Job Sheet 165977

Part Name: 206A/B/L-Series Cable Cutter System, Low

APICAL INDUSTRIES, INC.	ENGINEERING CHANGE NOTICE NO. 03047				SHEET 1 OF 1	
	DWG NO. 646.9500	REV: NC	PREPARED BY J. JACKSON	DATE: 01/24/11	EFFECT ON DWG ☐ INC. ☒ UNINC.	
	DWG TITLE: 206 CABLE CUTTERS KIT					
	APPROVED BY: ENGR. <i>[Signature]</i>	MFG <i>[Signature]</i>	QC <i>[Signature]</i>	EFF: NEXT ORDER		
TRANSACTION CODES (TC): A-ADD C-CREATE R-REVISE D-DELETE	REASON: ADDED GPS MOUNT KIT, F/N 52. REVISED DRAWING VIEWS. ADDED NOTE <u>2</u> .

206 CABLE CUTTERS KIT

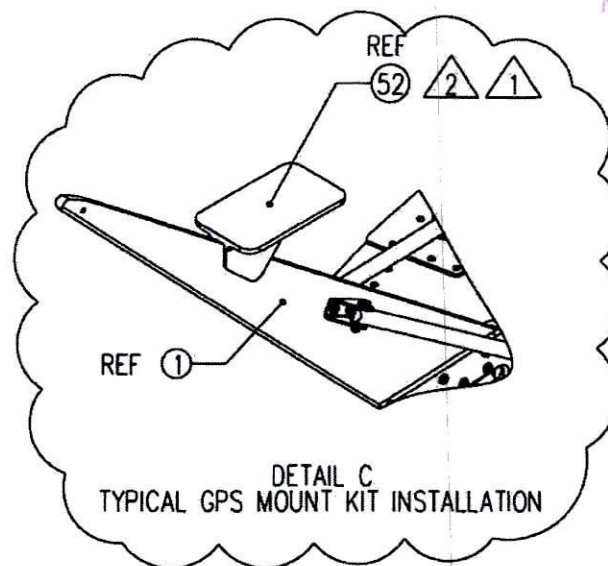
SHEET 1, ZONE B1 IS:

2 AT CUSTOMERS OPTION, INSTALL F/N 52 BY MATCH DRILLING ONTO F/N 1.

SHEET 2, ZONE A3 IS:

SHEET 2, ZONE B2 IS:

52	A	647.5701	REF	REF	GPS MOUNT KIT	<u>2</u>	
F/N	TC	PART NUMBER	.9502	.9501	DESCRIPTION	MATERIAL	SPECIFICATION
			QTY				
DOCUMENTS EFFECTED:						CHANGE CATEGORY ☐ MAJOR ☒ MINOR	DER REVIEW REQUIRED ☐ YES ☒ NO
☐ MDL ☐ INSTALL INSTRU ☐ ICA ☒ BOM

SHEET 2, VIEW IS:

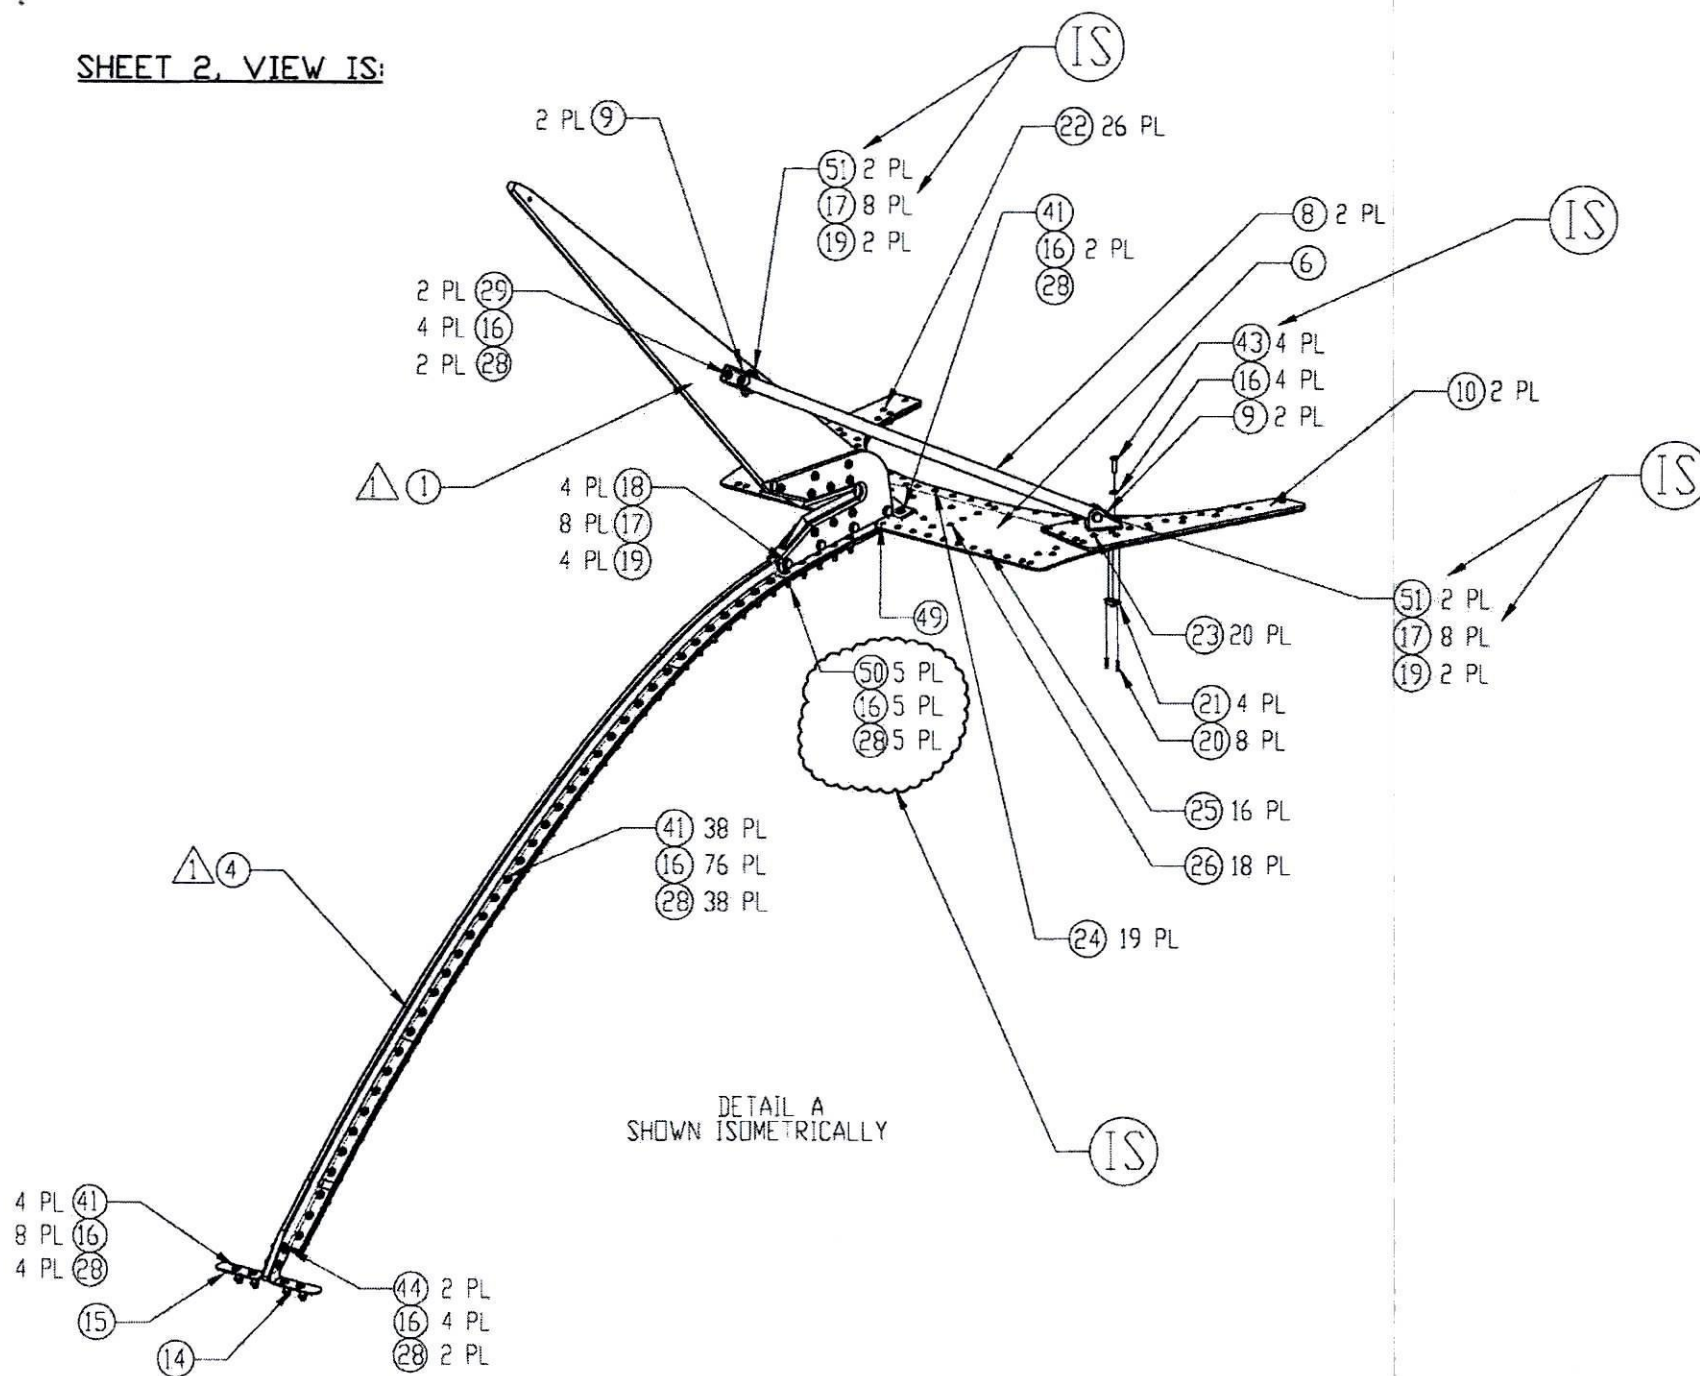
APICAL INDUSTRIES, INC.	ENGINEERING CHANGE NOTICE NO. 02729				SHEET 1 OF 3	
	DWG NO. 646.9500	REV: N/C	PREPARED BY S. HUFF	DATE: 12/23/09	EFFECT ON DWG ☐ INC. ☒ UNINC.	
	DWG TITLE: 206 CABLE CUTTERS KIT					
APPROVED BY:		ENGR <i>[Signature]</i>	MEG <i>[Signature]</i>	QC <i>[Signature]</i>	EFF: CURRENT ORDER	
TRANSACTION CODES (TC) A-ADD C-CREATE R-REVISE D-DELETE		REASON: HARDWARE REVISIONS FROM FIRST INSTALL

51	A	601.3155	8	8	BOLT	AN3-10A
50	A	601.3153	5	5	SCREW	MS24694S8
41	R	601.2893	43	43	SCREW	MS27039-0811
28	R	601.2973	54	54	LOCKNUT	MS21042-08
18	R	601.2826	8	8	BOLT	AN3-11A
16	R	601.2764	127	127	WASHER	NAS1149FN832P
			9502	9501		
F/N	TC	PART NUMBER	QTY		DESCRIPTION	MATERIAL/SPECIFICATION
DOCUMENTS EFFECTED:						CHANGE CATEGORY ☐ MAJOR ☒ MINOR
☐ MDL ☒ INSTALL INSTRU ☒ ICA ☐ FMS ☒ BOM						DER REVIEW REQUIRED ☐ YES ☒ NO

SHEET 3, ZONE B2, IS:

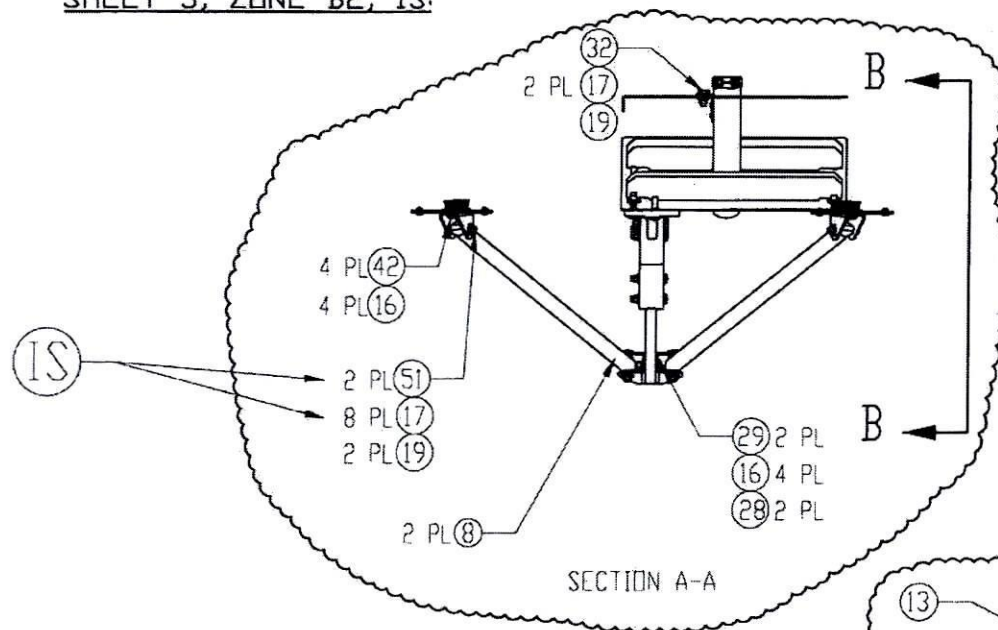
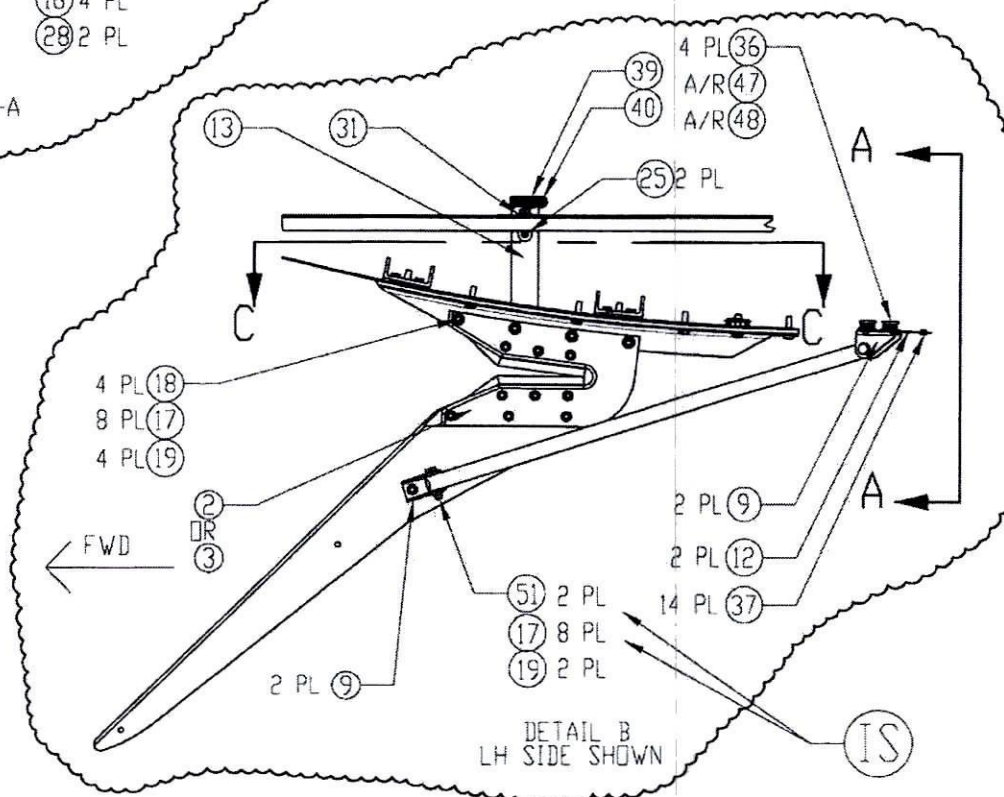
SHEET 3, ZONE D2, IS:
